Philadelphia Regional Port Authority
3460 North Delaware Ave. 2nd Floor
Philadelphia, PA 19134

**Re: ADDENDUM NO. 10
23-026.1 - RFP for Design Build of Temperature Controlled Warehouse**

PhilaPort TCW - Bid RFIs

GENERAL RACKING PLAN

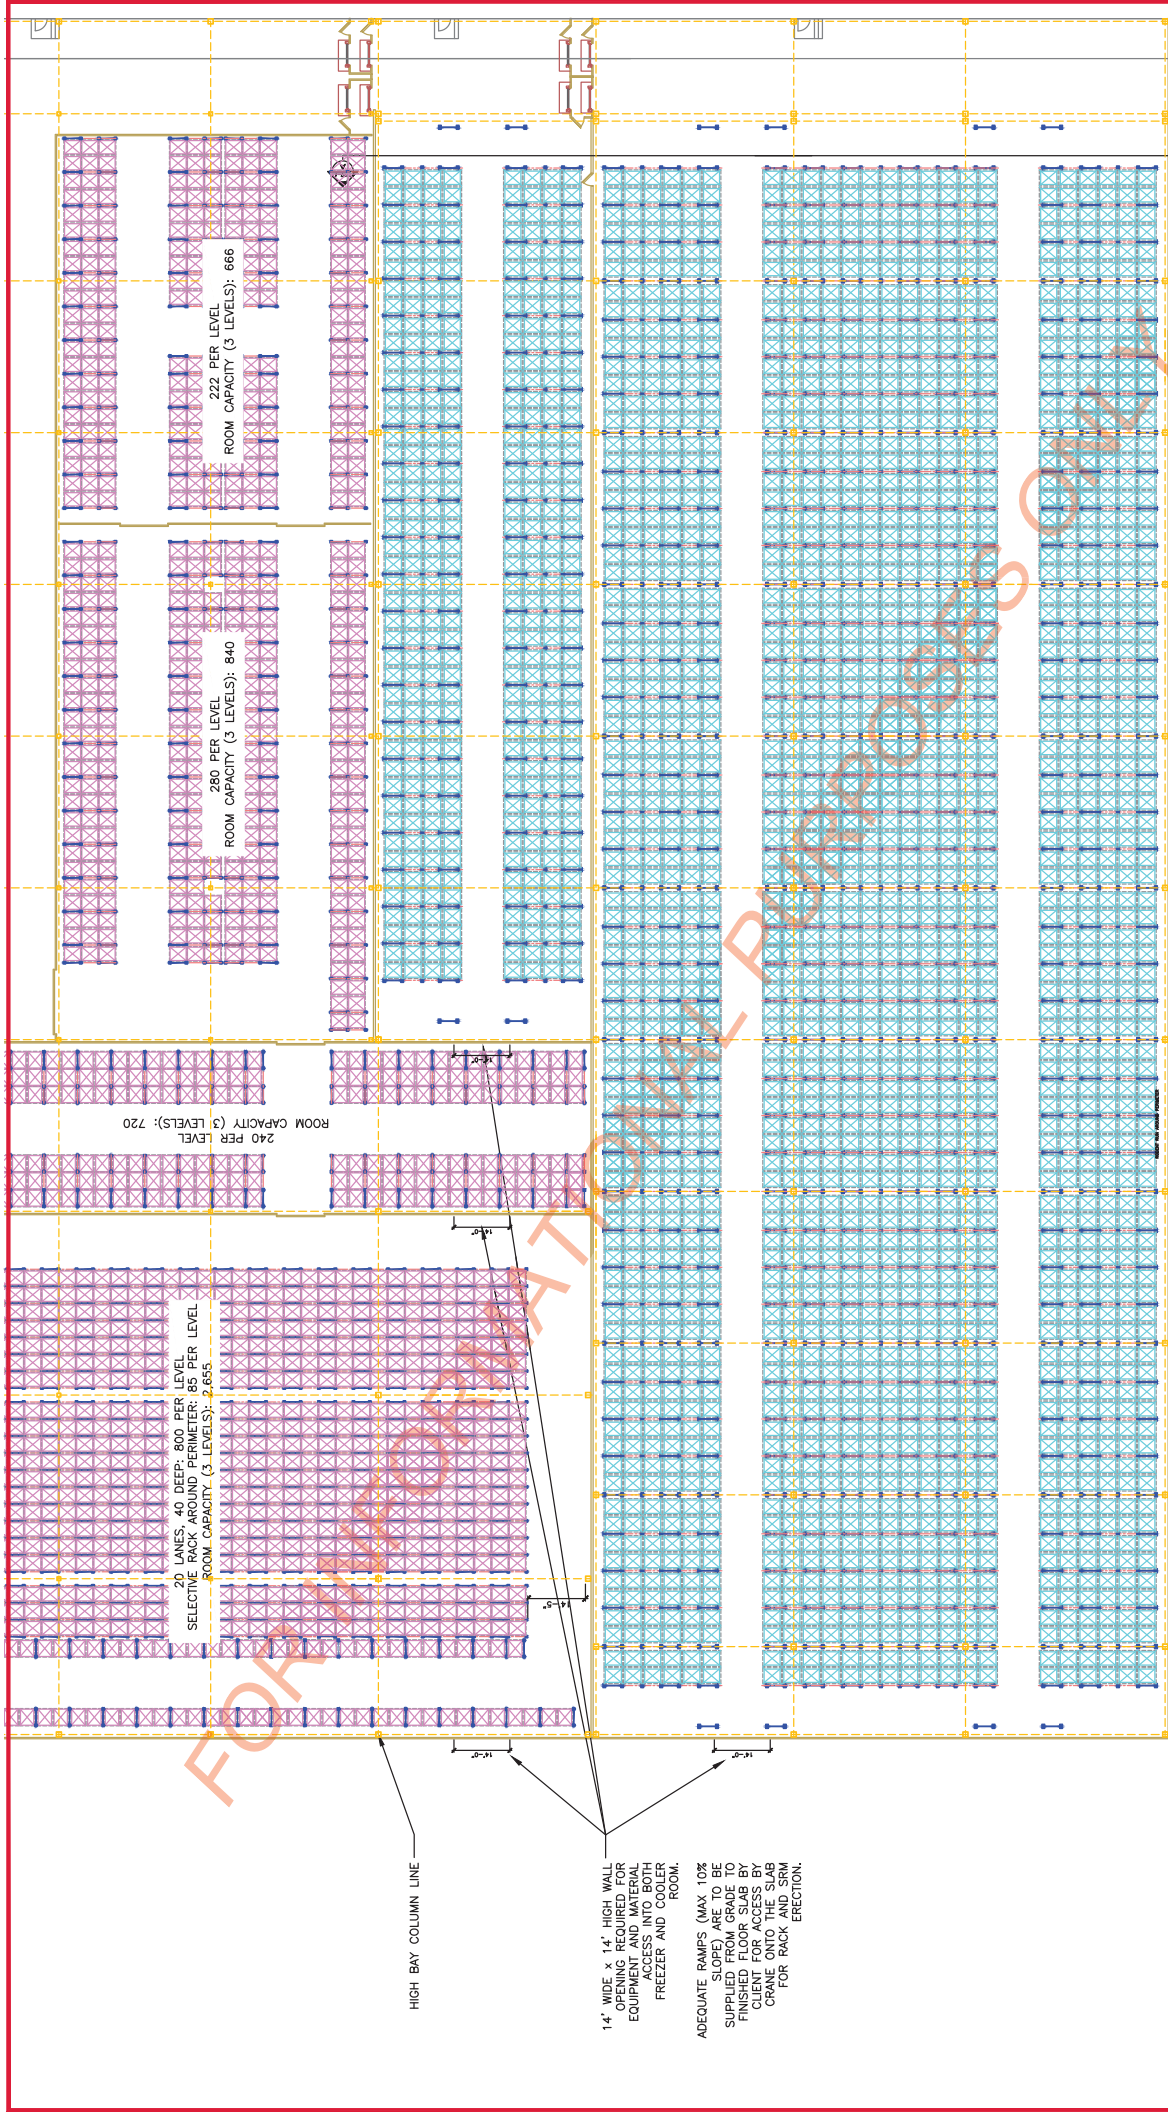
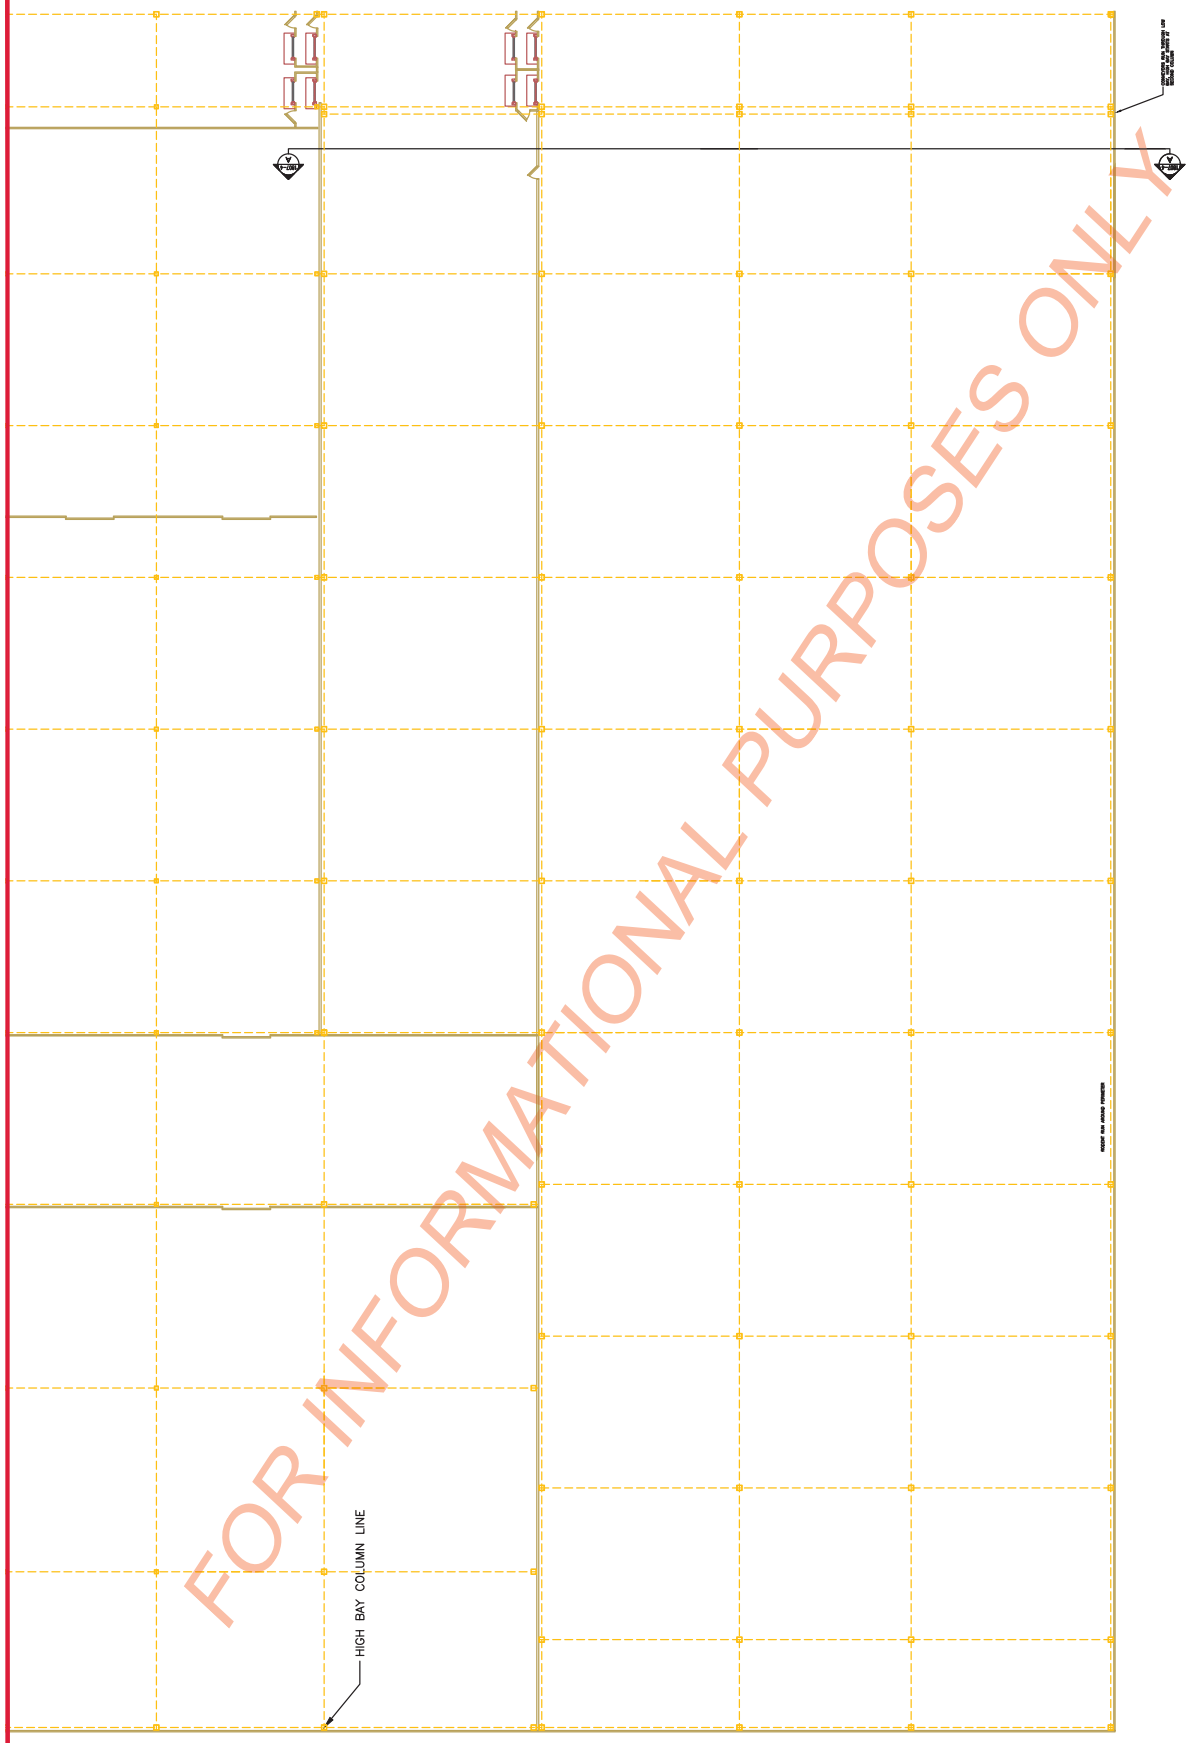
114	Roof details do not clearly show continuity of vapor barrier from TPO to IMP metal siding. Please confirm if an appropriate connection should be designed for continuity? A-301	Yes, vapor barrier to be continuous. This detail is to be developed during detailed design phase.	Architectural
115	Please clarify for roofing: what thickness and warranty is required for the TPO? Should roof insulation be 2 layered and staggered? Should insulation be polyiso? Should roofing be fully adhered? A-301	DBC to complete specifications during detailed design. See notes sheet A-001. Note that warranty length for the roof is 20 years. Roofing is to be fully adhered.	Architectural
116	General note 3 indicates providing power for the future ASRS per vendor shop drawings. Will vendor shop drawings be provided as part of the RFP, and if not what should be assumed for power requirements? E-101	See attached general racking plan.	Electrical
